SERVICE LETTER 00003

Subject: Optional removal of F-1054 Tank Attach Angles

Affected Models: RV-10

FIGURE 2: LOWER WING ROOT FAIRING

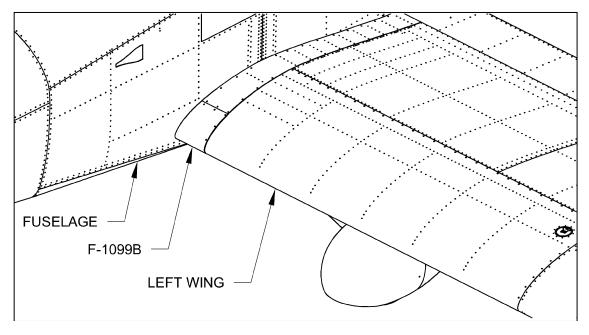
<u>Step 1:</u> Remove enough of the screws from the leading edge of the F-1099B Lower Wing Root Fairings that they can be pulled away from the wing to expose the F-1054-L/R Tank Attach Angles. See Figures 2 and 3.

FIGURE 3: REMOVING THE TANK ATTACH ANGLE

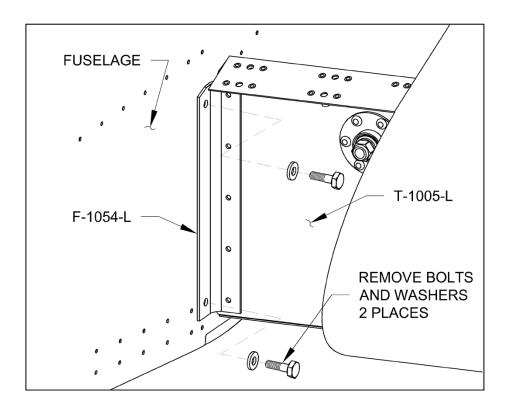
<u>Step 2:</u> Remove the two bolts securing the F-1054-L/R Tank Attach Angles to the fuselage. See Figure 3.

<u>Step 3:</u> Center-punch the manufactured heads of the rivets securing the tank attach angles to the T-1005-L/R Tank Attach Brackets, then, using a 12 inch-long #30 drill bit, drill out the rivets. Remove the angles.

Step 4: Reinstall the two bolts on each side or fill the holes with RTV.
